Development Application Accessibility Report

| Project Name | 149-151 Canberra Ave, Fyshwick |
| Reference | 10723 |
| Revision | 02 |

Figure A: site plan

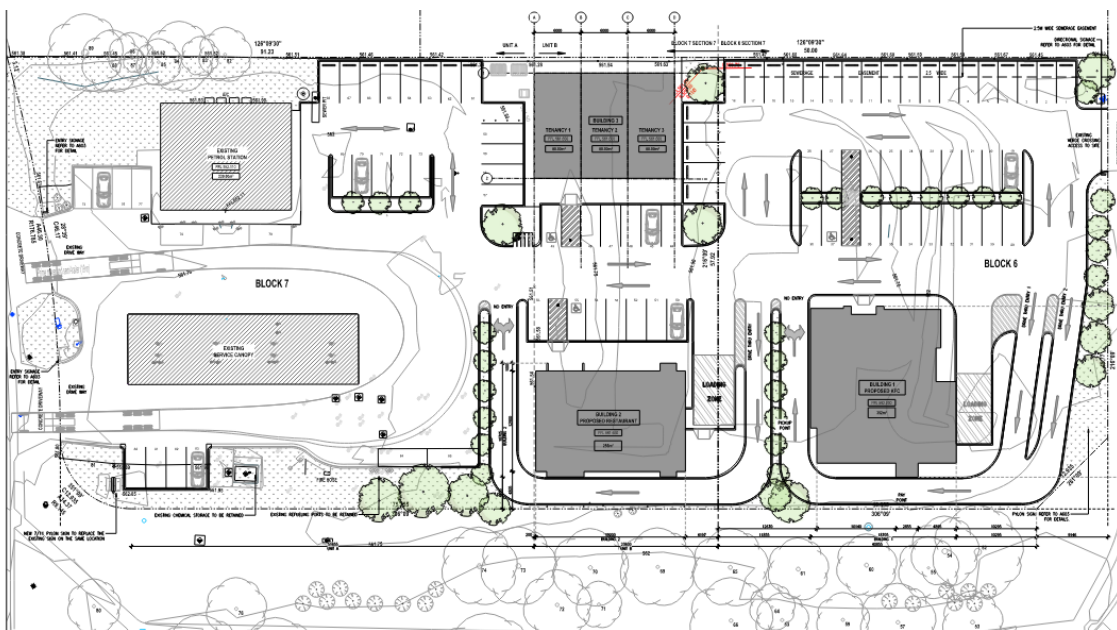
This development comprises 3 new single storey buildings. The existing service station and associated buildings on this site are not within the scope of this project.
